**Before the
FEDERAL COMMUNICATIONS COMMISSION
Washington, D.C. 20554**

PETITION FOR RECONSIDERATION

FM TRANSLATOR STATION K210CL
LEMON GROVE, CALIFORNIA
CHANNEL 210D, 89.9 MHz

FCC FILE NUMBER: BPFT-20020328AAT

FIGURE 1
K210CL 100 dBu
INTERFERENCE CONTOUR

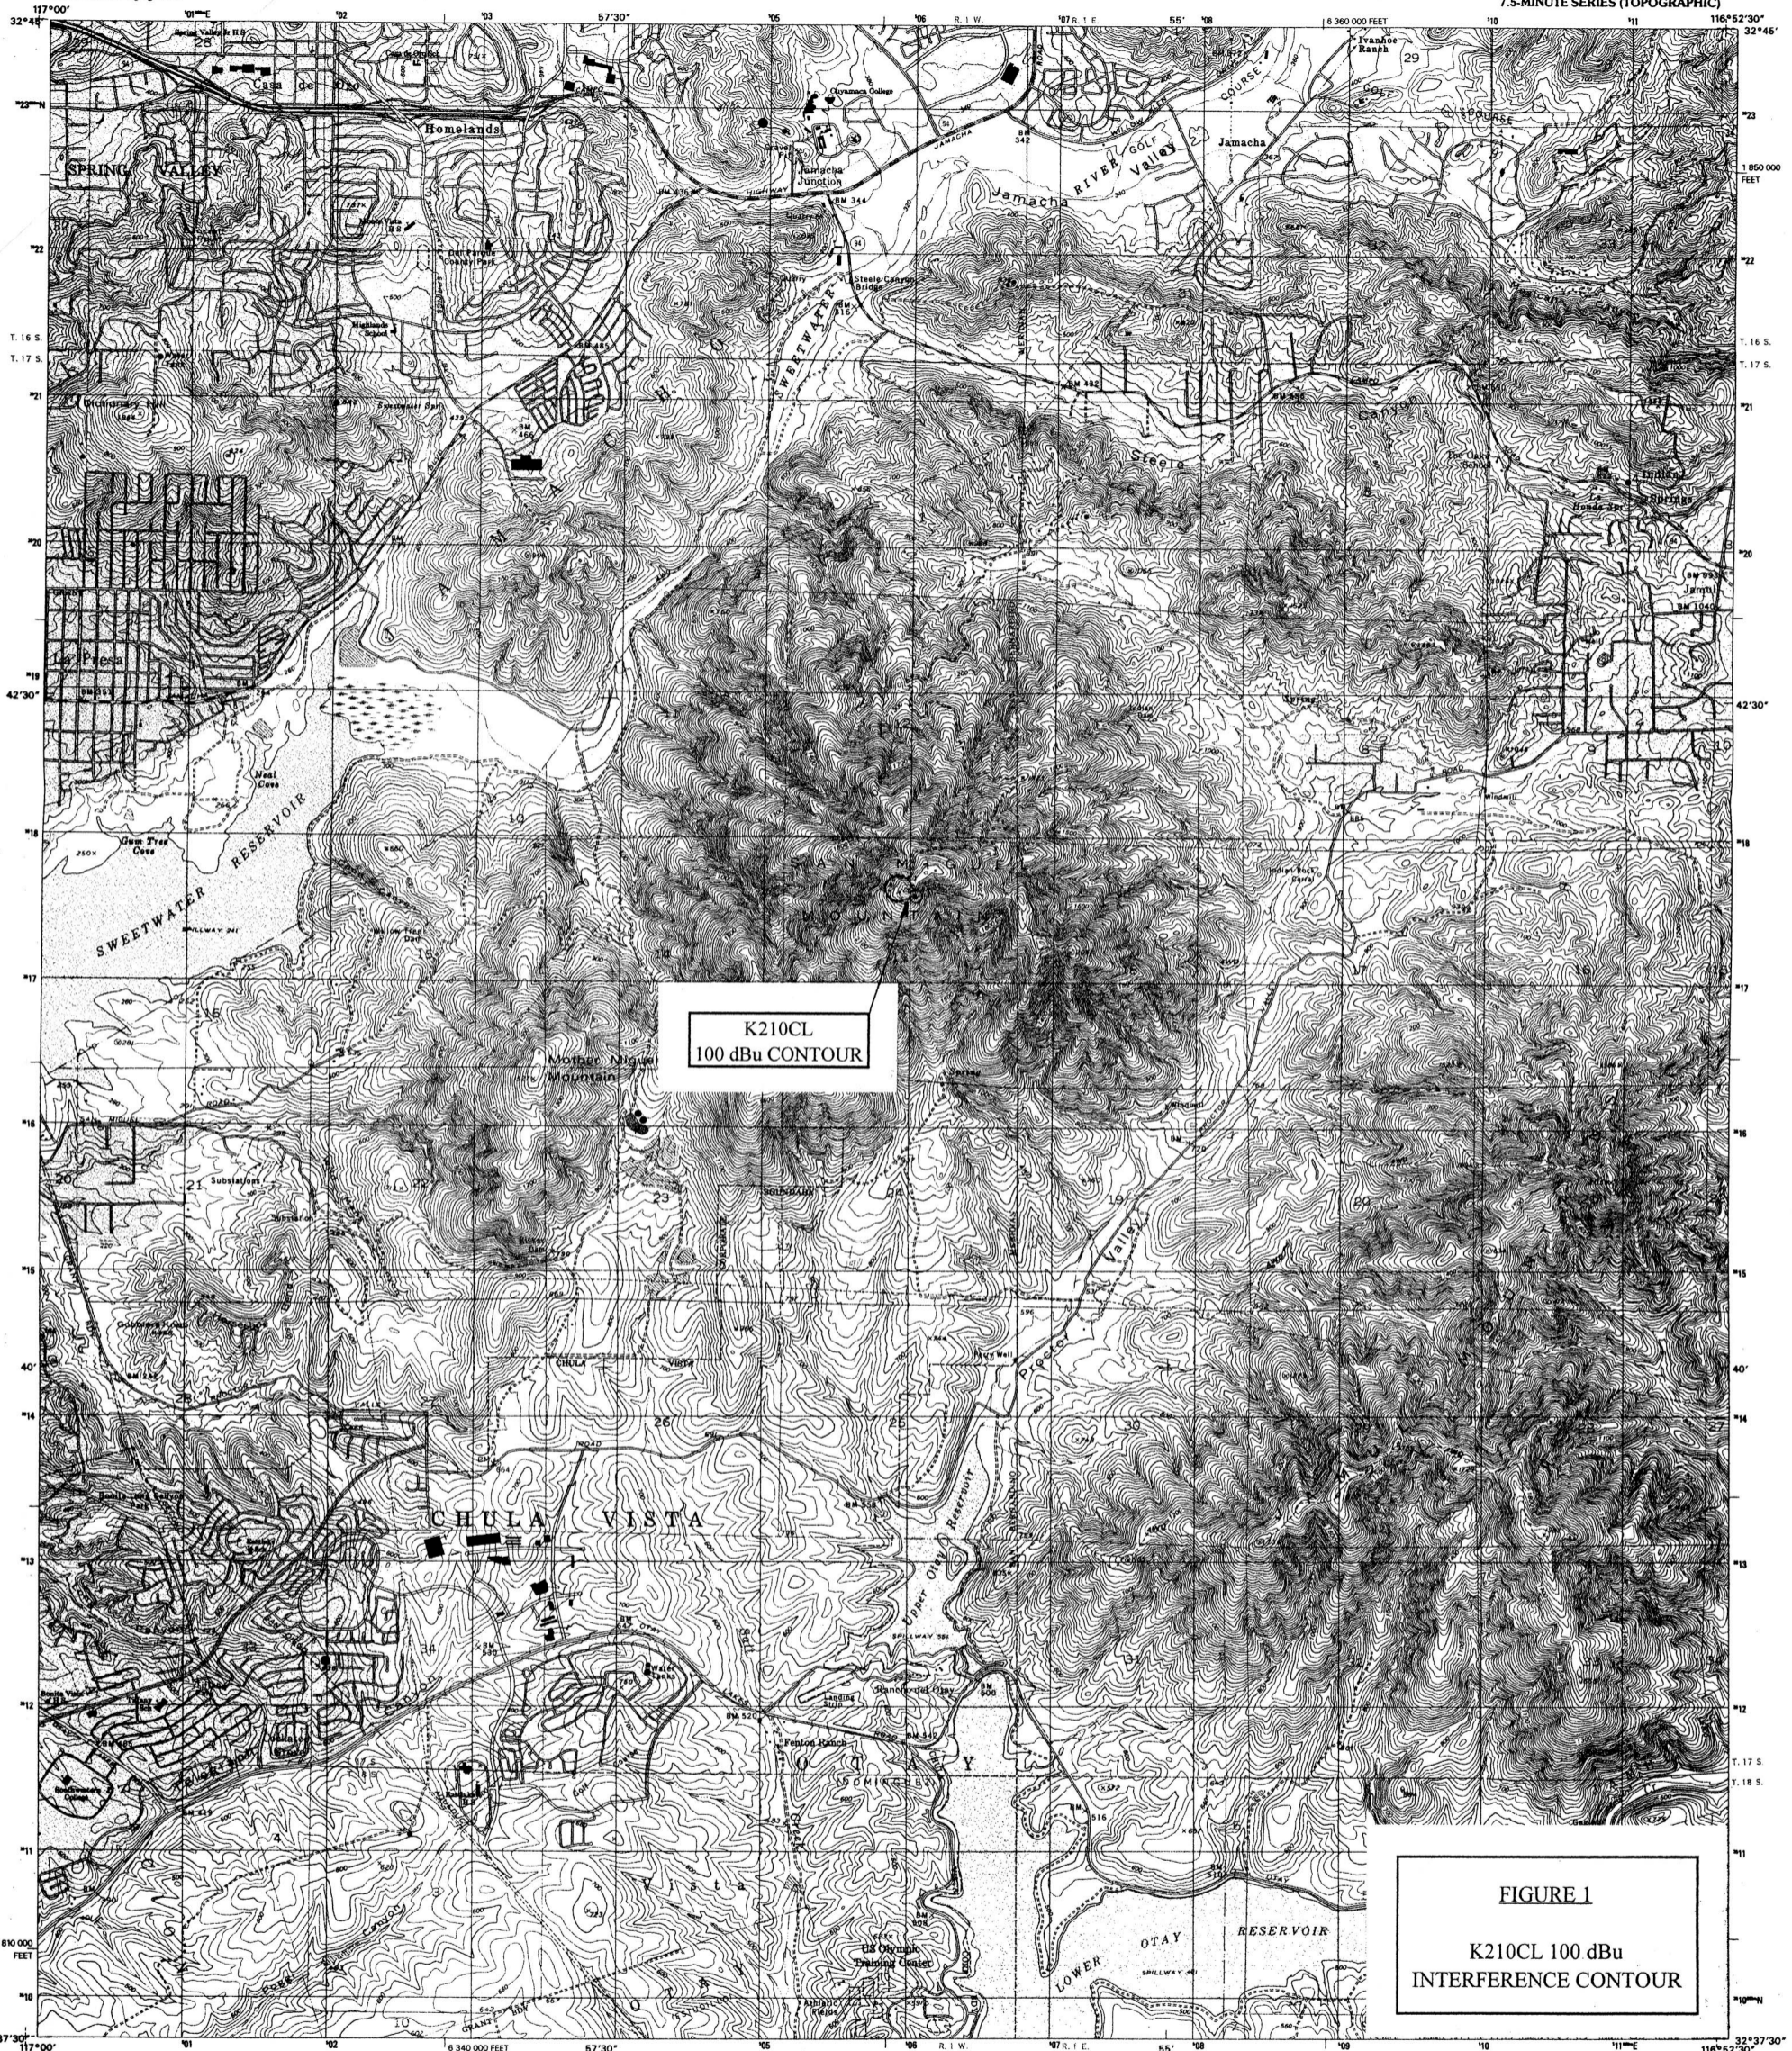
Figure 1 shows the Jamul Mountain 7-1/2 minute USGS topographic quadrangle (50% reduction). The K210CL translator's 100 dBu interference location is plotted on this map. It is evident from this map that the area, for a considerable distance from the translator site, is mountainous and unpopulated.
